WITNESS STATEMENT OF BRIAN R. GRAY, M.Eng., P.Eng.
(Reply Evidence)

RE: HALTON LANDFILL UNDERTAKING

2. At the request of David Estrin, Barristers & Solicitors, I have reviewed evidence and reports presented by Conestoga Rovers and Associates (CRA) with respect to their position as to the need for a liner at Site F, and as to whether or not, assuming that a liner is deemed necessary, one could be constructed from on-site materials. I have also reviewed CRA's cost estimates for construction of a liner at Site F.

Site "F" Development

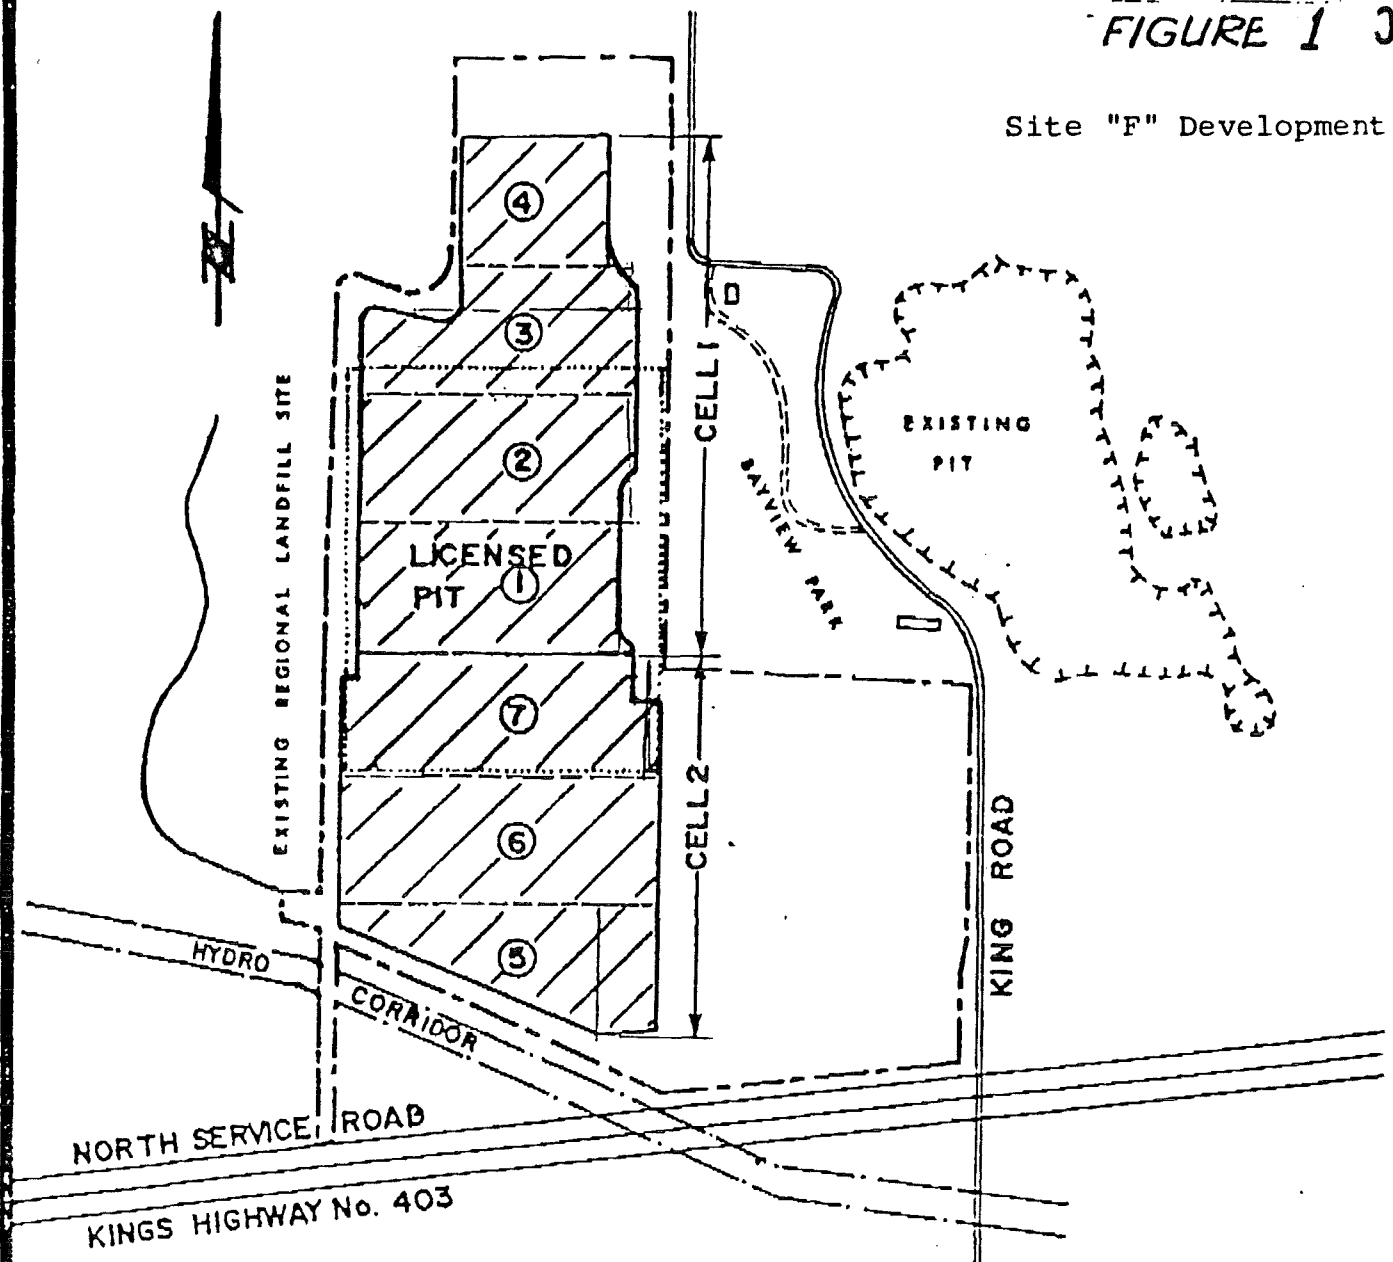
14. Figure 1 with attached Commentary illustrates how development of Site F could proceed if the base elevations are lowered by 1m and only on-site material is used for liner and cover.

- (a) Commence cell 1 construction by stripping topsoil and excavating shale proceeding in south to north direction (parcels 1 to 4).
- (b) Haul clay fill borrow from parcels 3 and 4, spread and compact to form berms and dykes.

- (c) Haul, spread and compact cut fill material (shale and/or clay) at all infill areas (parcels 1, 2, and 3).
- (d) Haul clay fill borrow from parcels 3 and 4, spread and compact to form liner, initially parcels 1 and 2.

- (e) Stockpile of surplus cut material only in later stage of cell 1 construction. Deficit of available materials in parcels 1 and 2 to meet requirements.

- (f) Proceed with clay liner construction in parcels 3 and 4 and placement of daily and final cover as landfill development progress.
- (g) Commence cell 2 construction by stripping topsoil and excavating shale proceeding in south to north direction (parcels 5 to 7).

- (h) Haul clay fill borrow from parcel 5, spread and compact to form berms and dykes.
- (i) Haul, spread and compact cut fill material (shale and/or clay) at all infill areas (parcels 5, 6, and 7).

- (j) Haul, spread and compact clay fill borrow in parcels 5 and 6 to form liner.
- (k) Stockpile of surplus cut material only in later stage of cell 2 construction.

- (l) Proceed with clay liner construction in parcel 7 and placement of daily and final cover as landfill development progress.

FIGURE 2

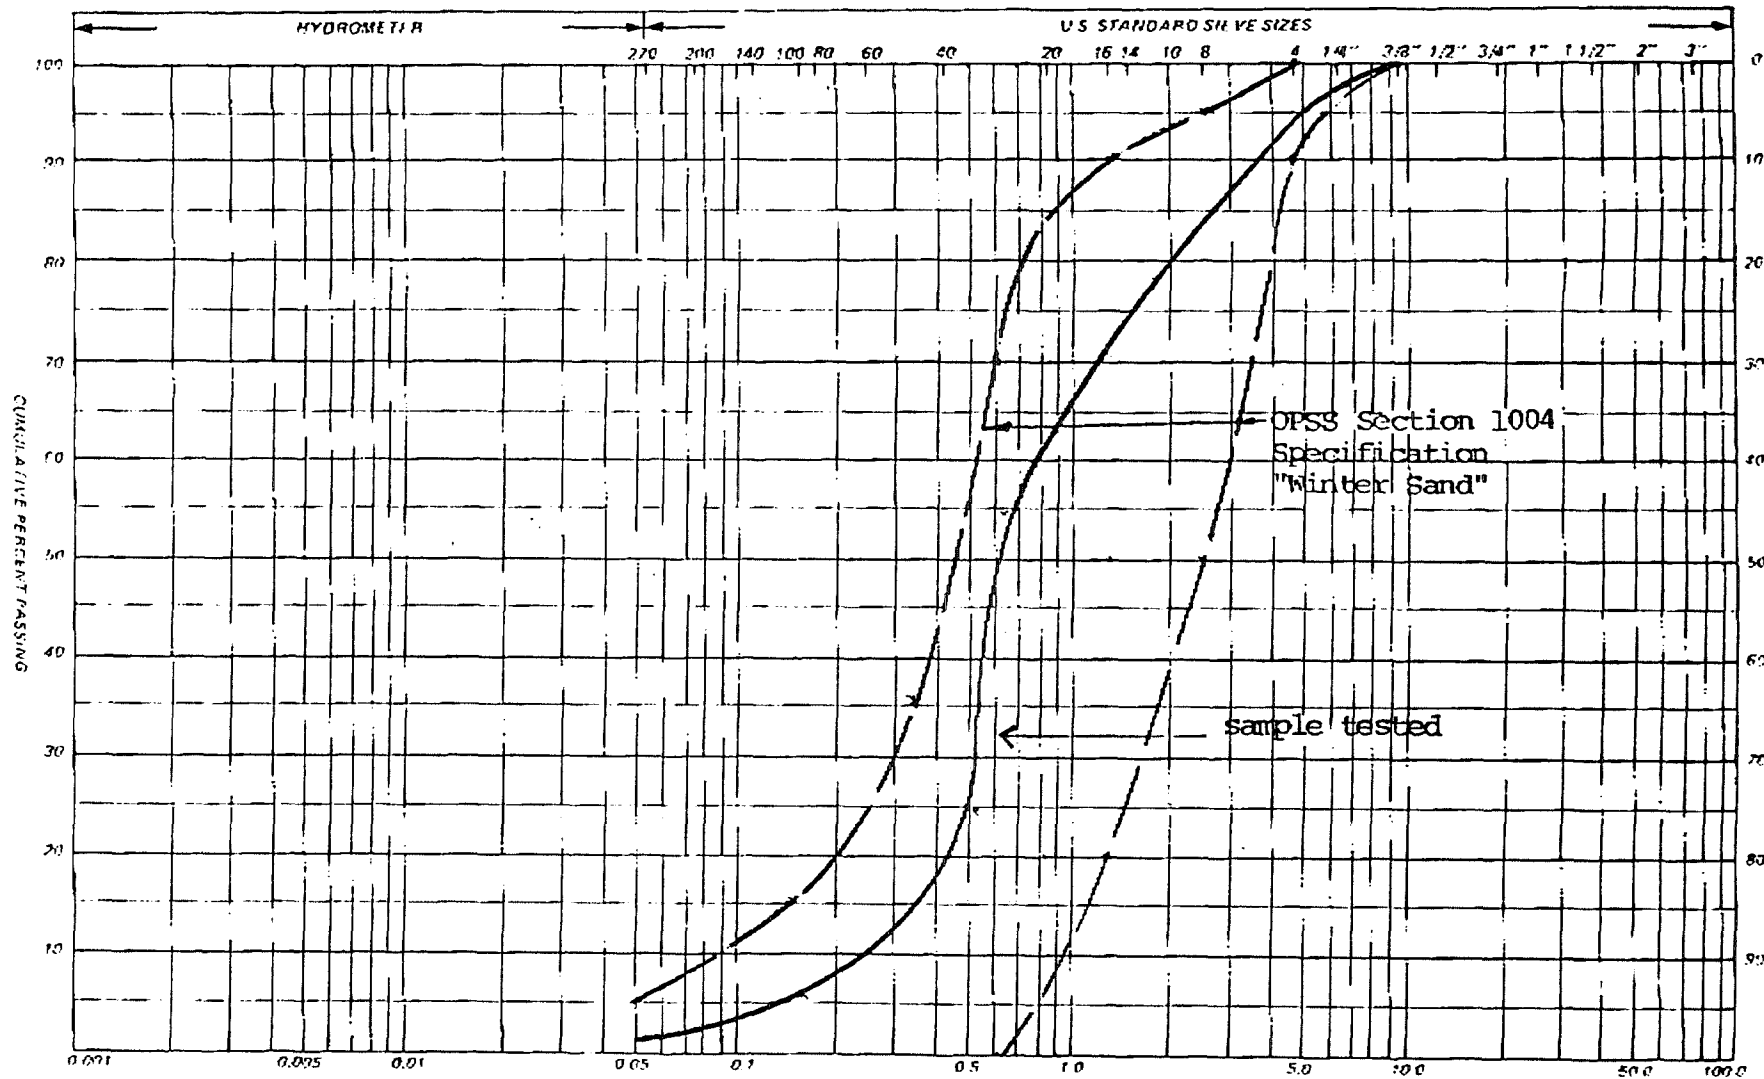
17. Figure 2 presents the results of a grain size analysis of a sample of "winter sand" that was obtained from Sherman

Sand & Gravel Ltd. and delivered to our laboratory. As shown on Figure 2, the sample meets the MTC gradation requirements for winter sand (Ontario Provincial Standard Specification #1004).

FIGURE 3

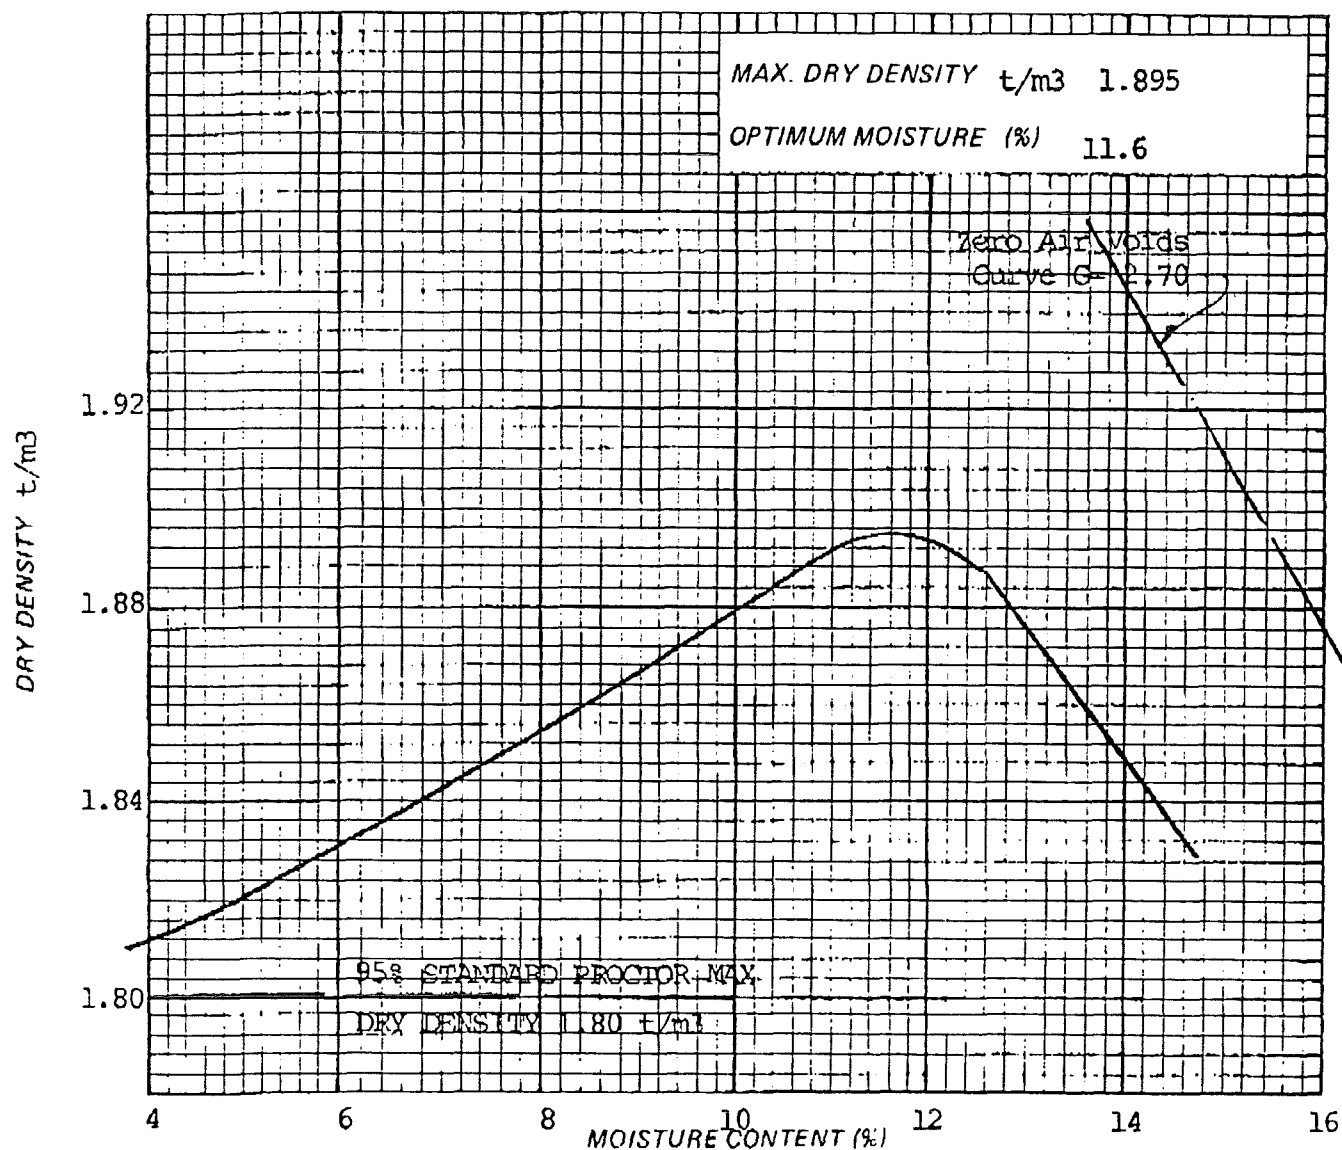
18. Figure 3 presents the results of a standard Proctor compaction test conducted on the same sample of winter sand. The results of a falling head permeability test on a sample prepared in our lab at 95% standard Proctor compaction density yielded a coefficient of permeability of 2×10^{-2} cm/sec. This correlates well with the estimate of the coefficient of permeability using Hazen's formula which would give about 8×10^{-1} cm/sec to 1×10^{-2} cm/sec.
19. Assuming that a sand blanket is deemed necessary at Site F, Sherman Sand & Gravel's "winter sand" would be suitable material for the purpose.
